We welcome the opportunity to comment on Ofwat's consultation on the economic asset valuation for the bioresources RCV allocation at PR19. We support the overall principles set out in the consultation. Our comments relate to the detail of the implementation of the proposed approach, and are intended to ensure that the objectives set out in the consultation can be achieved. We would be happy to discuss with you any of the issues which we have raised.

United Utilities response to the Ofwat consultation: Economic asset valuation for the bioresources RCV allocation at PR19

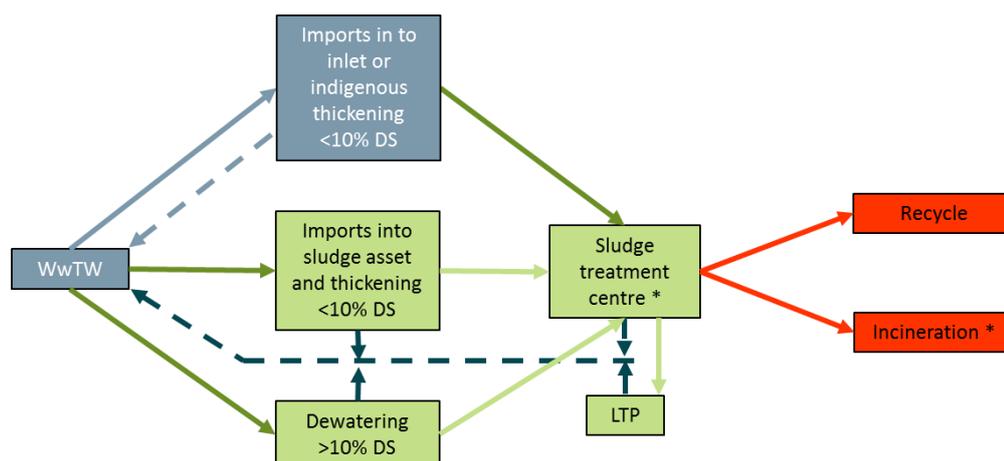
Table 4.1 states that "for the purposes of RCV allocation companies should use the definition in RAG 4.06". However, two of the statements in Table 4.1 appear to be inconsistent with RAG 4.06:

- “All transfers between intermediate sites should be included within sludge transport.”¹

Our interpretation of ‘intermediate sites’ is between two Bioresources Sludge Treatment Centres. RAG 4.06 states for Sludge Transport that “transport within the sludge treatment plant or between sludge treatment plants is not included in this service, which is instead an activity of the ‘sludge treatment’ service.”

- “Sludge assets (including storage for blending, mixing and consolidation with imported sludge) should use the 10% de-watering threshold for inclusion within the valuation.”

Our interpretation from RAG 4.06 is that the following should be considered as Bioresources Sludge Treatment and therefore included within the Bioresources valuation:

- Indigenous Sludge Thickening > 10% DS
- Sludge thickening < 10% DS where sludge has been imported into a sludge asset
- Transport of sludge from one sludge treatment centre to another sludge treatment centre

We agree that there needs to be consistency between RAG 4.06 and the definitions for asset valuation so clarification in the final valuation guidance would be valuable.

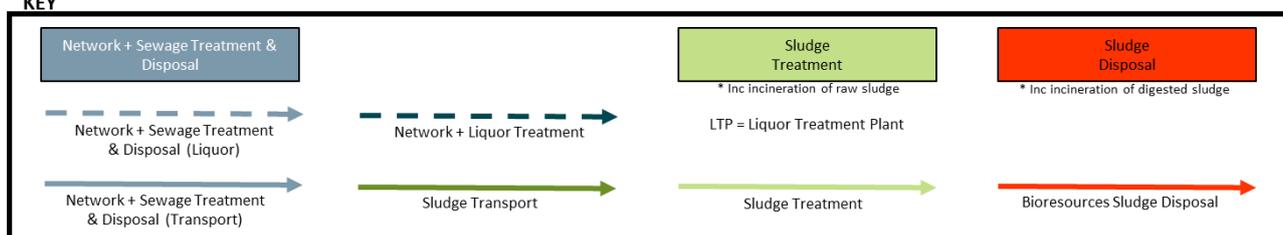
We would like to confirm the approach to sludge liquor treatment. RAG 4.06 Network+ sludge liquor treatment states “excludes liquor treatment which is done at a self-contained sludge processing centre”. However, all treated liquors (including from a liquor treatment plant) are returned to Wastewater Network+ flow. We would expect a Liquor Treatment Plant to be owned and operated by the Bioresources price control and therefore within Sludge Treatment not Network+ sludge liquor treatment. Separate Liquor Treatment Plants would therefore be included within the Bioresources valuation.

This is demonstrated by the following diagram:
